<b>BW Project No.:</b>	24-12-247
<b>BW Project Title:</b>	DPW. 25269 UI Campus Drive Repairs, Phase 3
<b>Client:</b>	University of Idaho
<b>Date:</b>	04-23-2026
<b>Addendum #:</b>	002

This addendum consists of a total of 4 pages and 16 drawings.

# UI: CAMPUS DRIVE REPAIRS, PHASE 3 UNIVERSITY OF IDAHO

HORIZONTAL  
CONTROL  
PLAN -  
INTERIOR  
C2.1

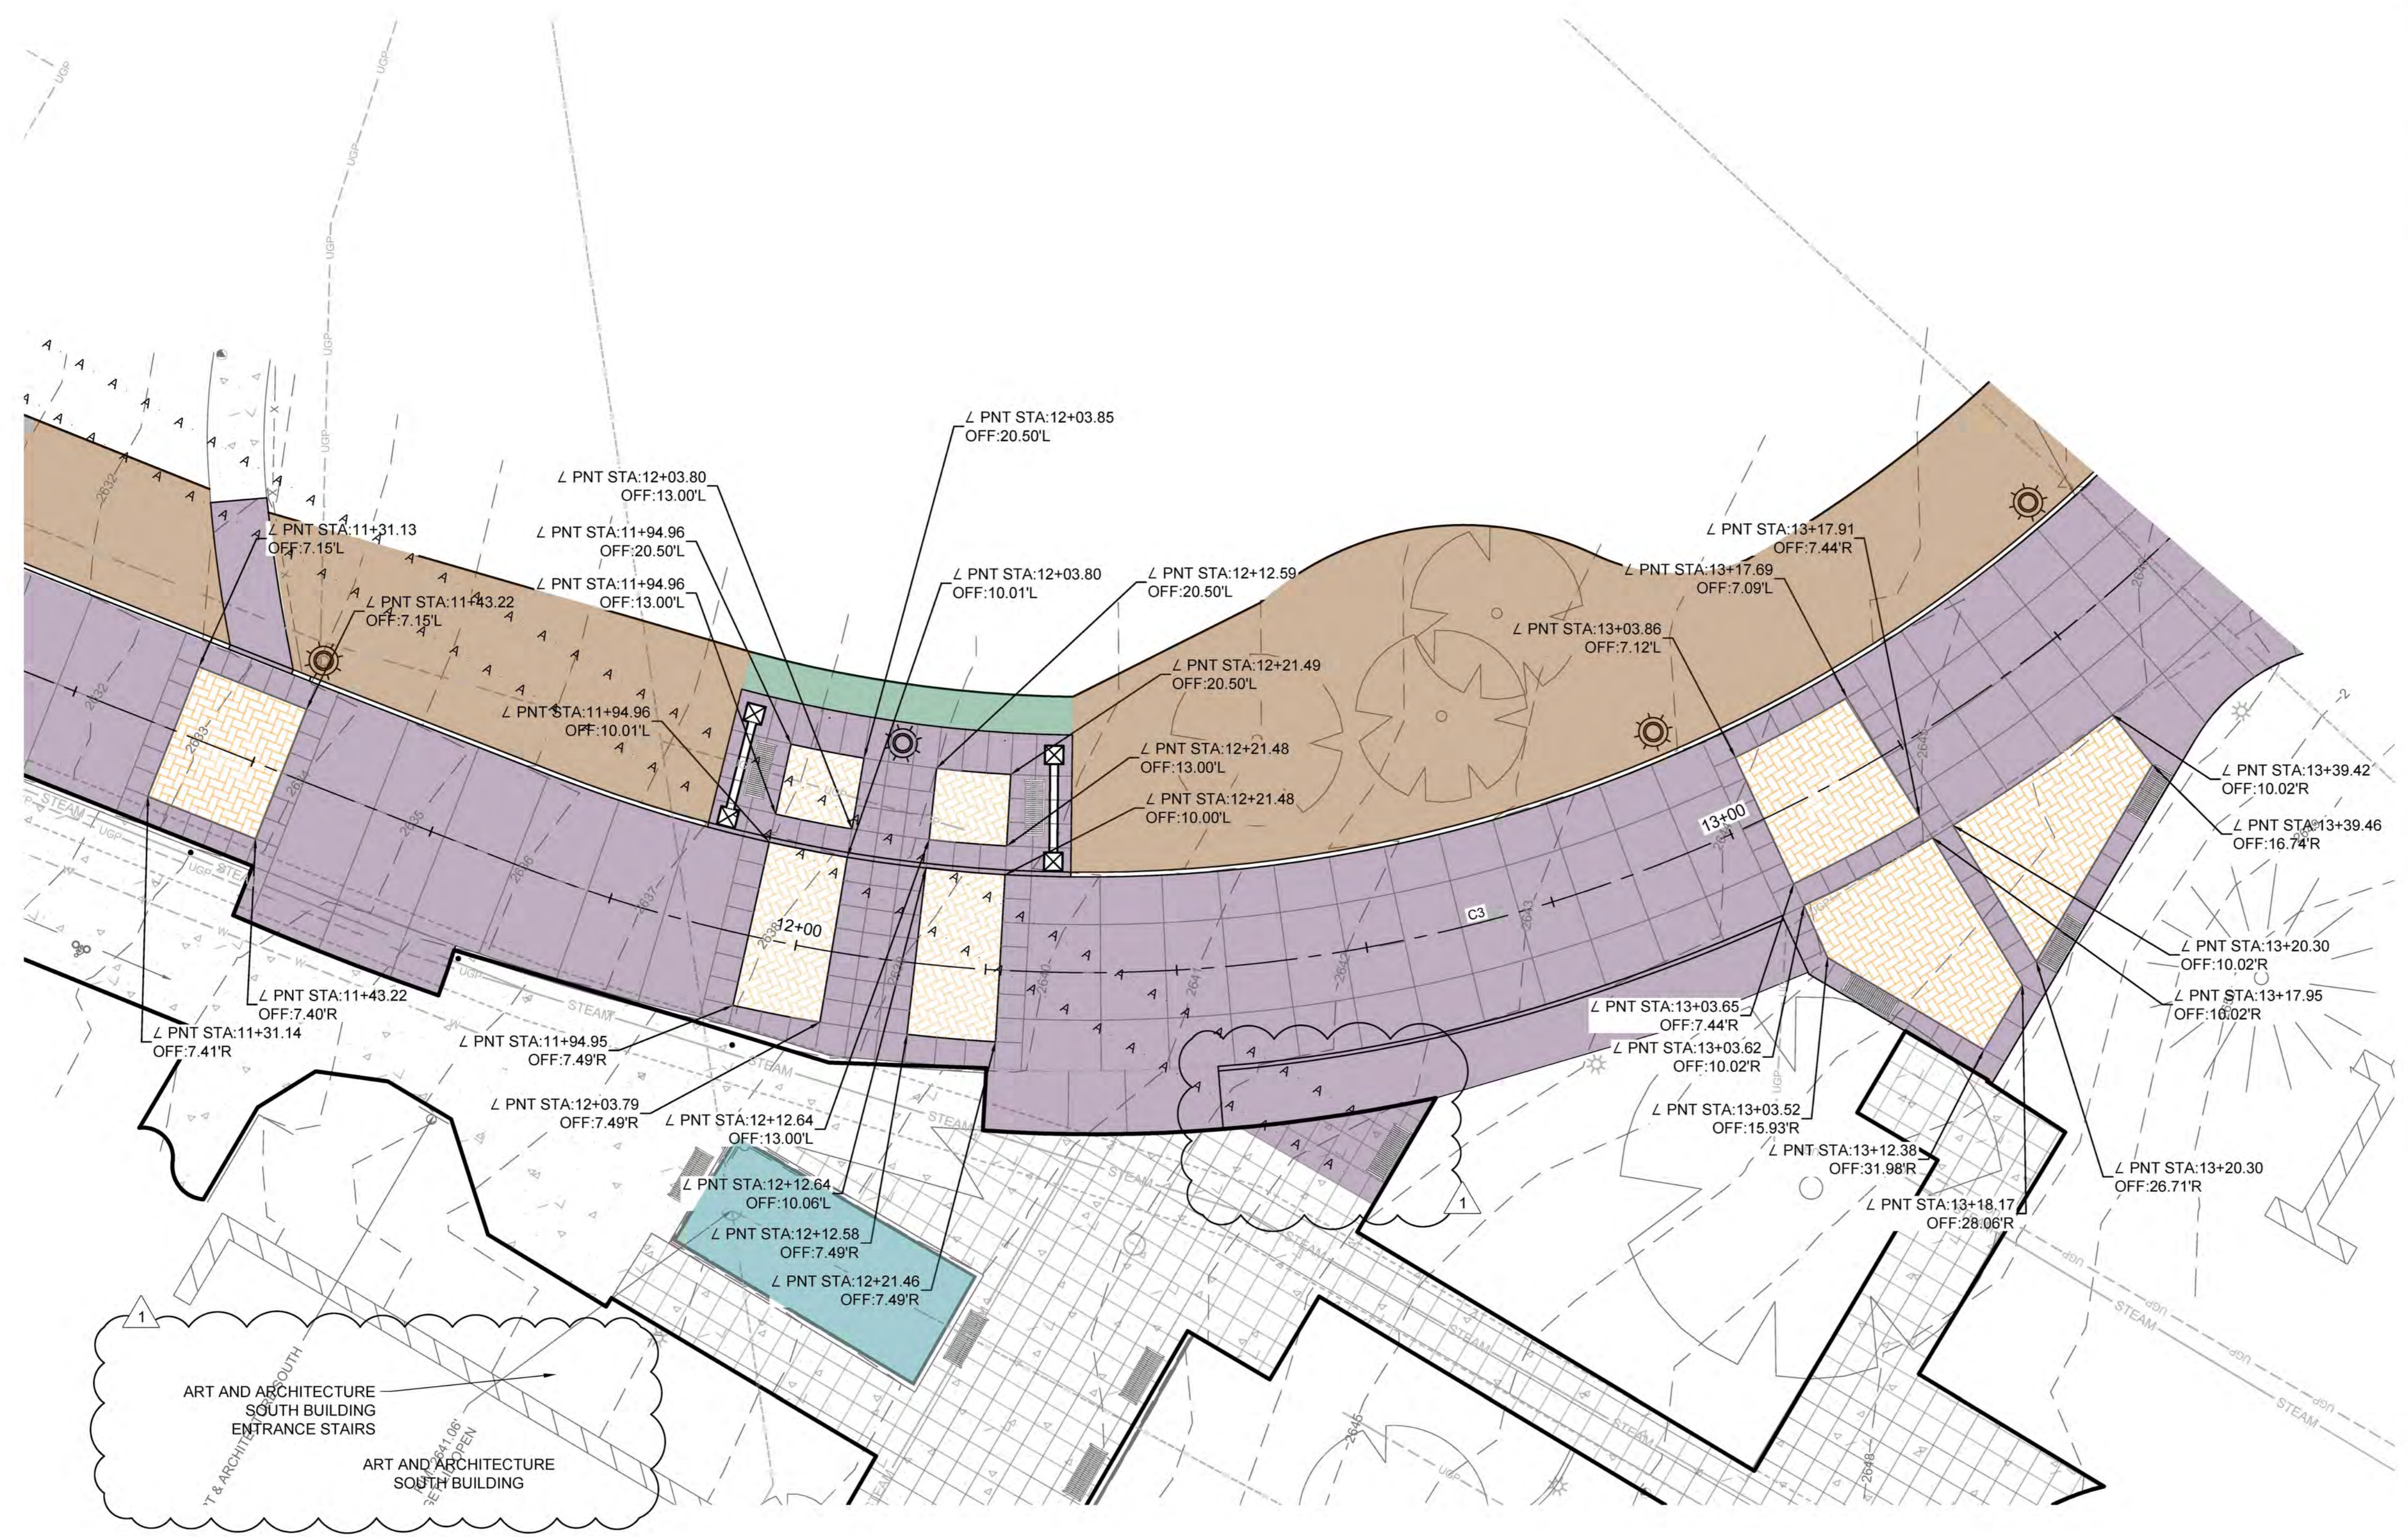
12. Sheet C2.0: Added fire lane signage.
13. Sheet C2.1: Noted Art & Architecture South Stairs and building.
14. Sheet C5.1: Updated concrete patch details to remove red paint at curbing.
